Service Bulletin

American Honda Motor Co., Inc.

SAFETY RECALL

2012 NC700X/XD DRIVE CHAIN INSPECTION/REPLACEMENT

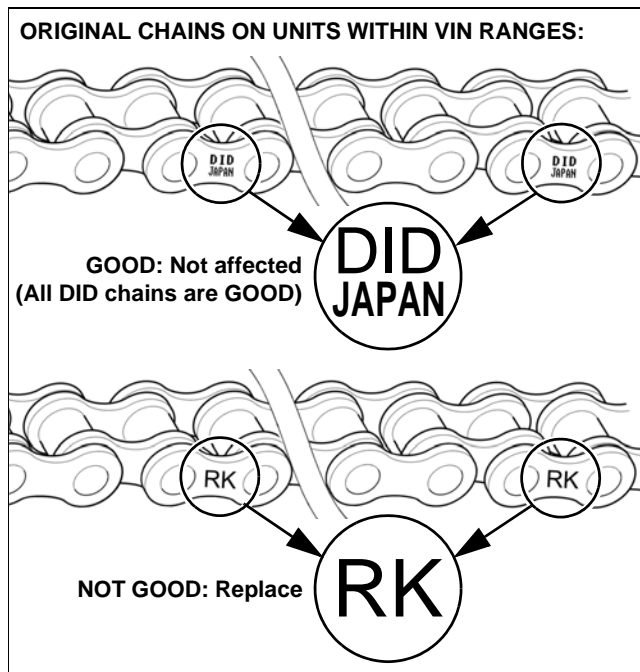
- If there IS a punch mark on the frame (on the left centerstand bracket), the unit HAS been inspected/repared and no further action is necessary.
- If there is NO punch mark, the unit has NOT been inspected/repared and you must proceed with the INSPECTION PROCEDURE section of this Service Bulletin.

After you have completed the INSPECTION PROCEDURE and, if necessary, the REPAIR PROCEDURE, make a punch mark on the outside of the accessory centerstand left side bracket. See the image at the top of the column to the right for the punch mark placement location.

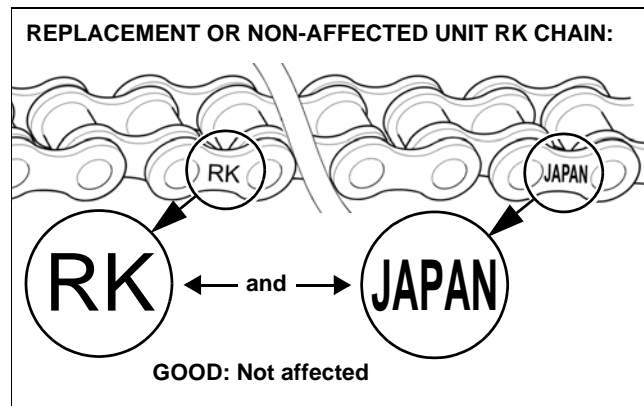
1. On a flat, level surface, securely support the motorcycle on its sidestand, accessory centerstand (if equipped), or an appropriate maintenance stand.
2. Inspect the chain outer plates for "DID Japan" or "RK" markings as shown below.

- If the chain is marked "DID Japan," the chain is **GOOD**. Proceed to the IDENTIFICATION section.
- If the chain is marked "RK" (without "JAPAN" marked on any link), the chain is **NOT GOOD** and must be replaced. Proceed to the REPAIR PROCEDURE.

IMPORTANT: All chains on units outside the AFFECTED UNITS VIN ranges are **GOOD** and must NOT be replaced. RK brand chains marked with both "RK" and "JAPAN," as shown below, are also **GOOD**.
